# Soberton Inc.

3/10/2016

Soberton Inc. has changed certain product specifications pertaining to part no. ST-0503 . These changes are highlighted below

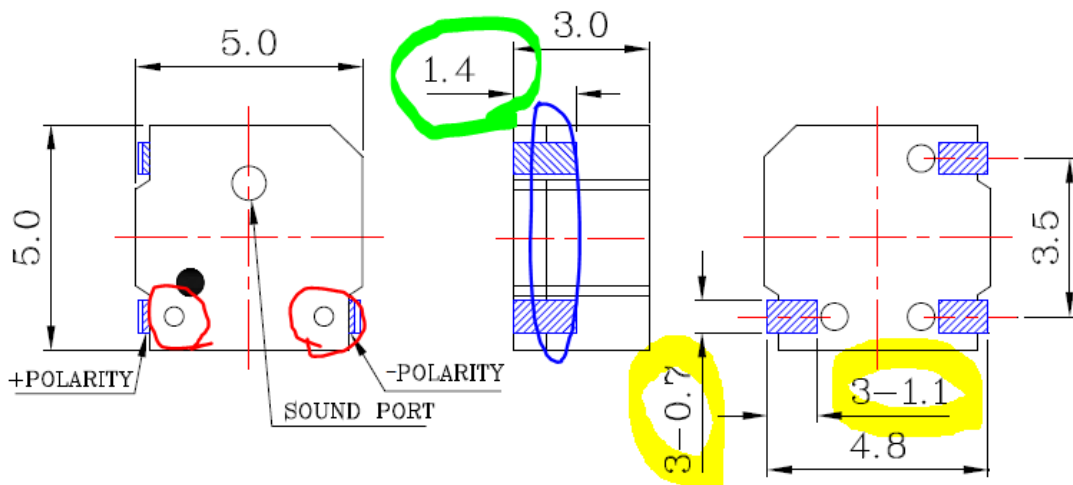
Part number	ST-0503 Old	ST-0503 New
Terminal Height	1.4mm	1.2mm
Terminal Length	1.1mm	1.5mm
Sound Output	78dBA	80dBA
Current Consumption	100mA	110mA

IMPROVEMENT1. To increase the terminal length ( 1.1mm == > 1.5mm ) width ( 0.7mm == > 0.8mm )  
 (Yellow): help soldering2. To reduce the terminal height ( 1.4 == > 1.2mm ) (Green):  
 away from the bonding line to reduce the flux penetration to buzzer from the gap3. To  
 reduce the flux penetration to buzzer from the gap3. To enhance bonding line (Blue):  
 to reduce the flux penetration to buzzer4. To delete two holes (Red): false  
 hole decorative hole, no function
